**Re: Response to California Public Utilities Commission Data Request No. 6**

The documents enclosed with this letter provide the responses of Horizon West Transmission, LLC (HWT) to Data Request Number 6 for the Estrella Substation and Paso Robles Area Reinforcement Project (project). Responses to each data request item are provided directly in the data request tracking table included as Attachment A. The accuracy of the project description changes provided in Table 1 of this Data Request is provided in Attachment B. The following figures are provided in Attachment C:

**Errata to Attachment 3 (Detailed Comment Table) of  
HWT's DEIR Comments**

**FIGURE 2-11**  
**Preliminary Substation Layout**

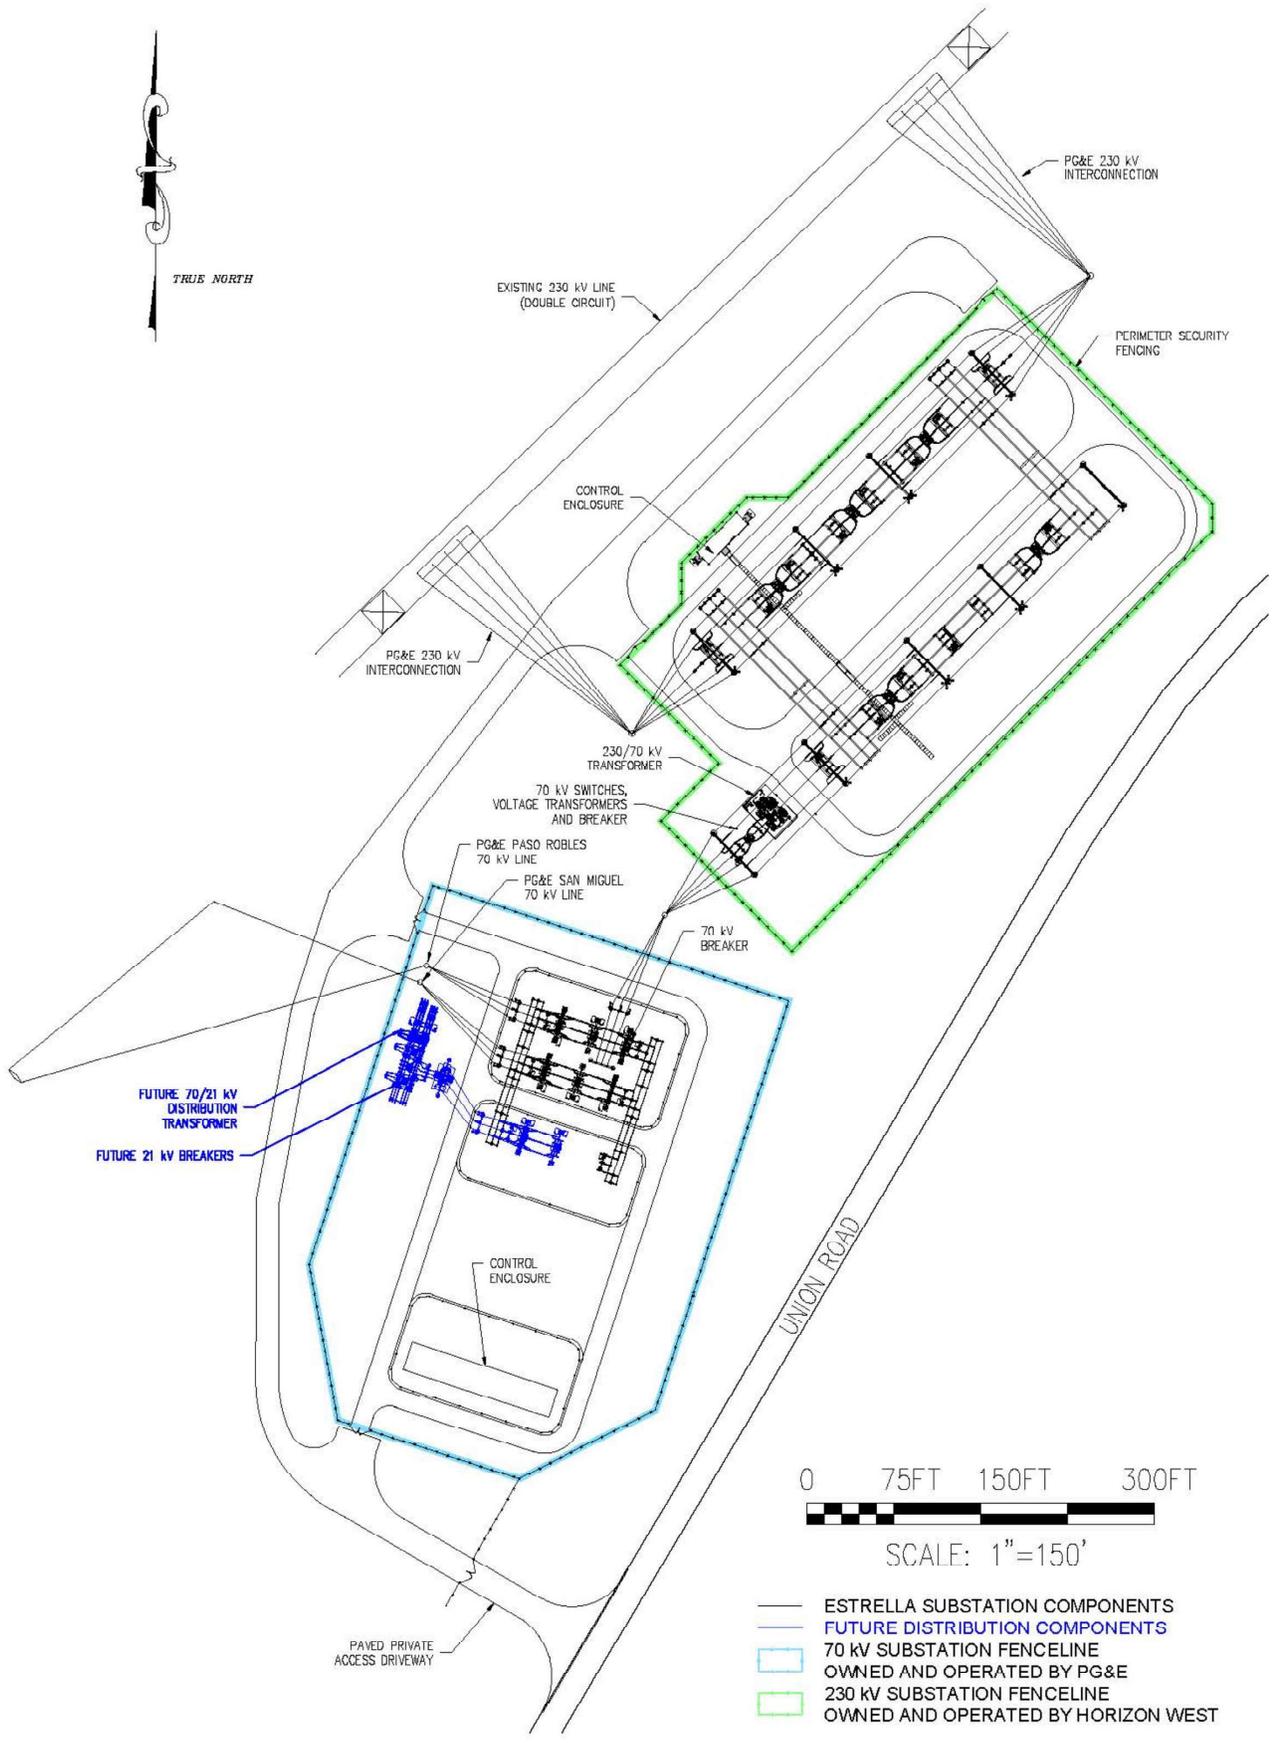
Page #	DEIR Language	Horizon West Transmission Comments
2-21	Access to the Estrella Substation site would be off of Union Road, along a new private access road. The access road would be paved up to the second entrance to the 70 kV substation (approximately 715 feet) and have an aggregate-surface up to the 230 kV substation access point and the 70 kV substation would have two separate access points	Please revise text to read:  Access to the Estrella Substation site would be off of Union Road, along a new private access road. The access road would be paved up to the second entrance to the 70 kV substation (approximately <del>715</del> 700 feet) and have an aggregate-surface up to the 230 kV substation access point and the 70 kV substation would have two separate access points
2-22	Figure 2-7	Replace figure to include new substation parcel and update temporary and permanent disturbance areas
2-46	Figure 2-11	Replace figure with new substation layout

**FIGURE 2-12**  
**Proposed 230 Kilovolt Substation General Arrangement**

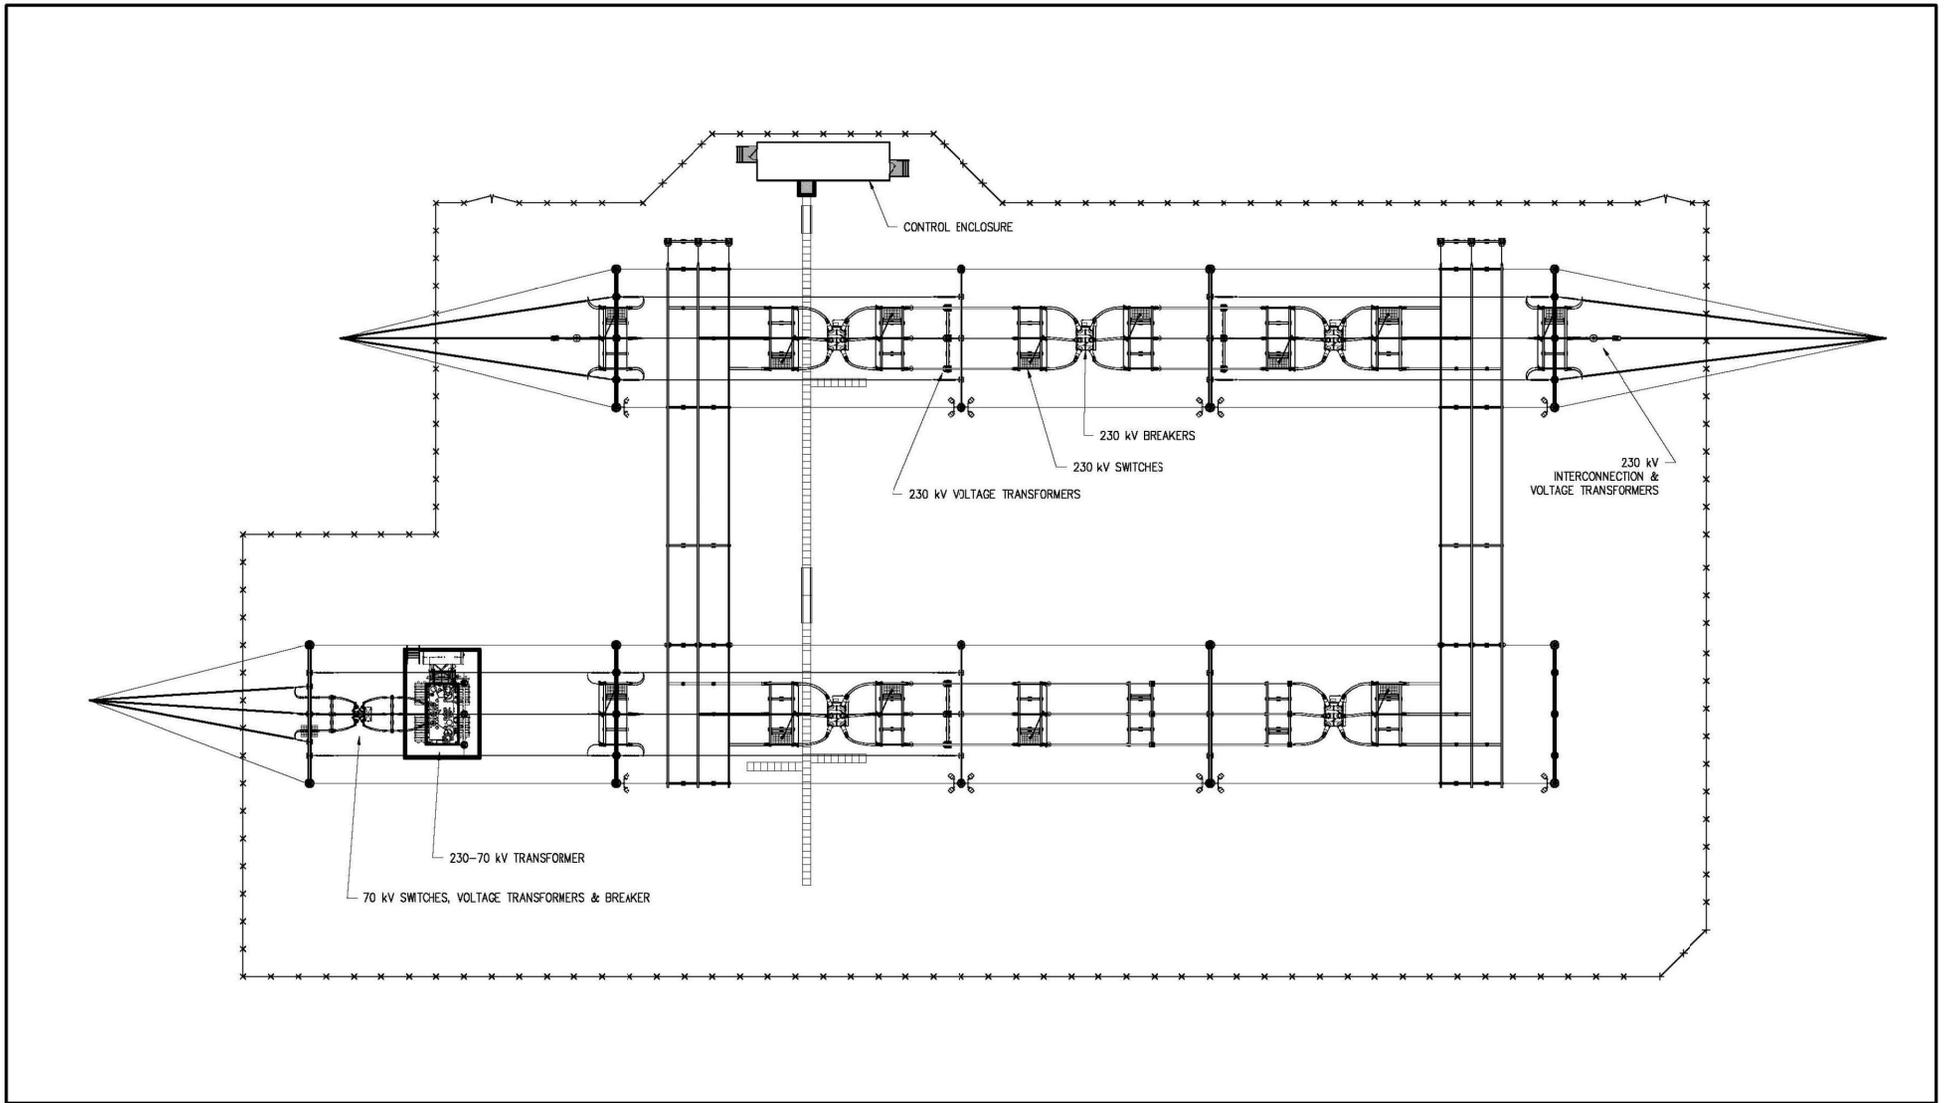
2-47	Figure 2-12	Replace figure with new substation layout
2-48	Figure 2-13	Replace figure with new substation layout
2-49	The fenced portion of the 230 kV substation would be approximately 4 acres in size. An approximately 7-foot-tall chain-link fence with an additional 1 foot of barbed wire would be installed around the remaining perimeter of the 230 kV substation.	Please revise text to read:  The fenced portion of the 230 kV substation would be approximately 4 acres in size. <del>An approximately 7-foot-tall</del> chain-link fence, <u>a minimum of 7 feet tall</u> , with an additional 1 foot of barbed wire would be installed around the remaining perimeter of the 230 kV substation.
2-56	The equipment and facilities associated with ultimate substation buildout would primarily be placed within the fence line of the already-constructed Estrella Substation. The anticipated layout of the Estrella Substation at ultimate buildout is shown in Figure 2-18. The additional 230/70 kV transformer under ultimate buildout is assumed to include the same amount of mineral oil (16,000 to 18,000 gallons) as described for the Proposed Project (see Section 2.3.1), and the same secondary containment structure (i.e., designed to allow sufficient freeboard to include the oil volume of the transformer plus the precipitation from a 25-year, 24-hour storm event). The additional 230 kV interconnection is assumed to include similar structures (LSTs) and follow a similar interconnection process to that described for the Proposed Project in Section 2.3.1 under the header for "230 kV Transmission Interconnection." The additional 70/21 kV transformers that may be installed to support additional distribution feeders are assumed to include secondary containment, as necessary to contain spills of any stored mineral oil.	Please revise text to read:  The equipment and facilities associated with ultimate substation buildout would primarily be placed within the fence line of the already-constructed Estrella Substation. The anticipated layout of the Estrella Substation at ultimate buildout is shown in Figure 2-18. The additional 230/70 kV transformer under ultimate buildout is assumed to include the same amount of mineral oil (16,000 to 18,000 gallons) as described for the Proposed Project (see Section 2.3.1), and the same secondary containment structure (i.e., designed to allow sufficient freeboard to include the oil volume of the transformer plus the precipitation from a 25-year, 24-hour storm event). The additional 230 kV interconnection is assumed to include similar structures (LSTs) and follow a similar interconnection process to that described for the Proposed Project in Section 2.3.1 under the header for "230 kV Transmission Interconnection." The additional 70/21 kV transformers that may be installed to support additional distribution feeders are assumed to include secondary containment, as necessary to contain spills of any stored mineral oil.

**FIGURE 2-18**  
**Ultimate Substation Buildout**

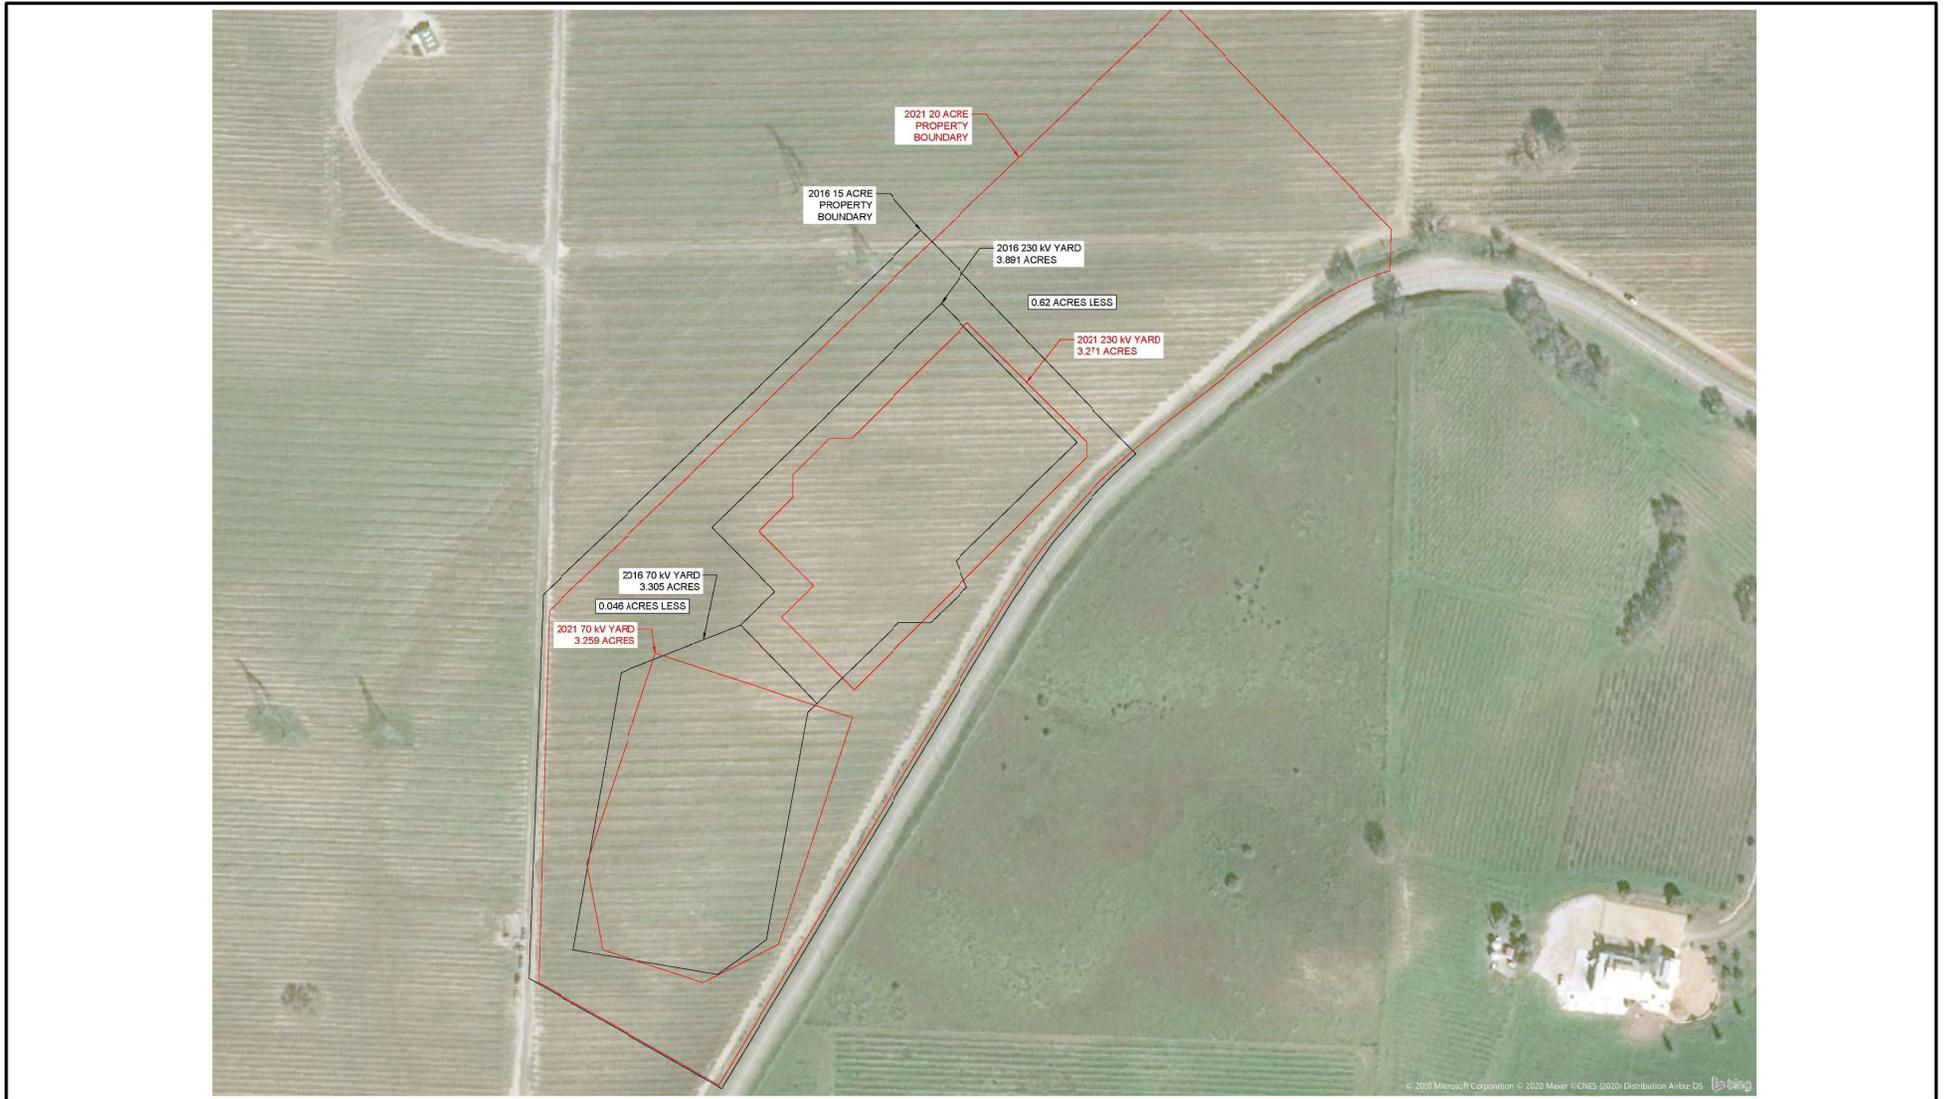
2-57	The additional 70/21 kV transformers that may be installed to support additional distribution feeders are assumed to include secondary containment, as necessary to contain spills of any stored mineral oil.	Please revise text as follows:  The additional 70/21 kV transformers that may be installed to support additional distribution feeders are assumed to include secondary containment, as necessary to contain spills of any stored mineral oil.
2-59	Figure 2-18	Replace figure with new substation layout

Figure 2-4. Estrella Substation Site Overview Map

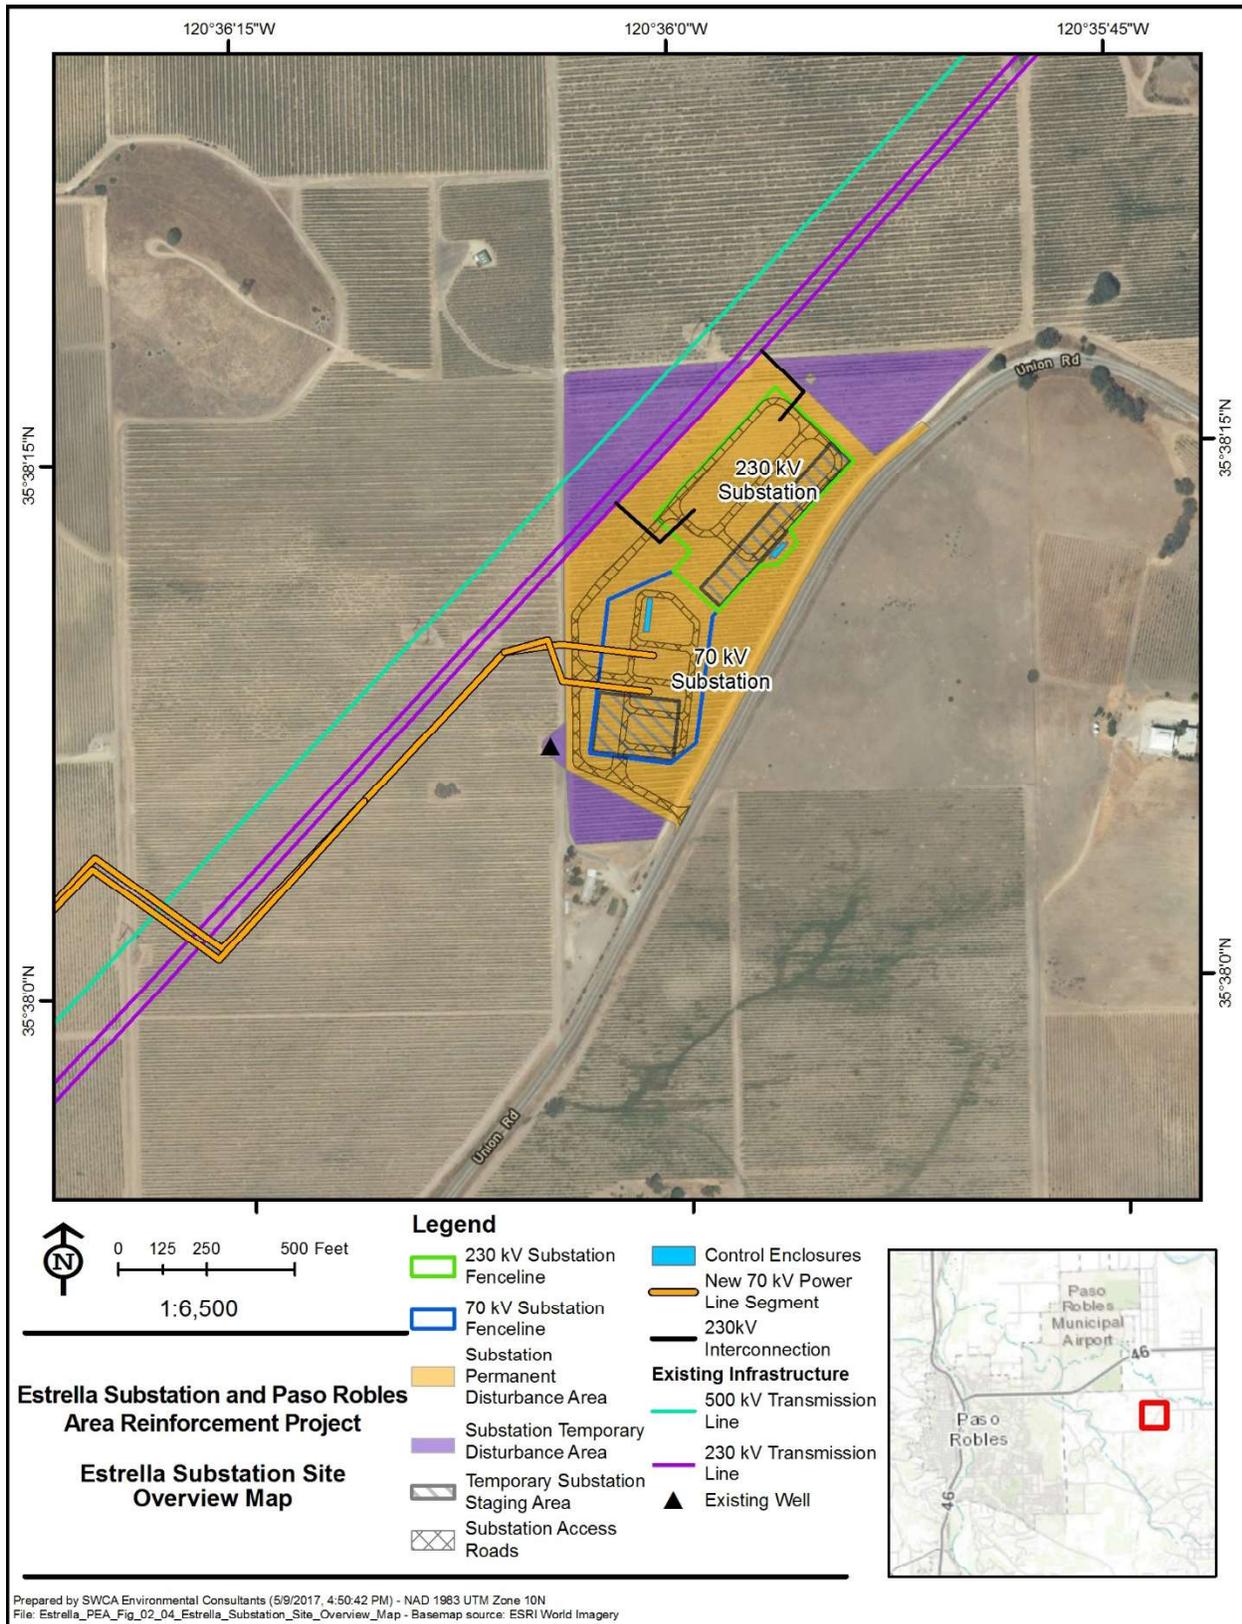
2-7	Figure 2-4	The 500kV line is north of the 230 kV line, not south as currently depicted in the figure.
2-20	<del>Permanent ground disturbance for Estrella Substation is approximately 15 acres, including the area that would be permanently disturbed outside of the 230 kV and 70 kV substation fence lines.</del>	HWT is acquiring a 20-acre parcel.  Please revise text to read:  <del>Permanent ground disturbance for Estrella Substation is approximately 15-20 acres, including the area that would be permanently disturbed outside of the 230 kV and 70 kV substation fence lines.</del>
2-21	Estrella Substation would be comprised of two separate and distinct substations on an approximately 15-acre site.	HWT is acquiring a 20-acre parcel.  Please revise text to read:  Estrella Substation would be comprised of two separate and distinct substations on <del>an</del> approximately 15 acres <del>within a 20-acre</del> site.
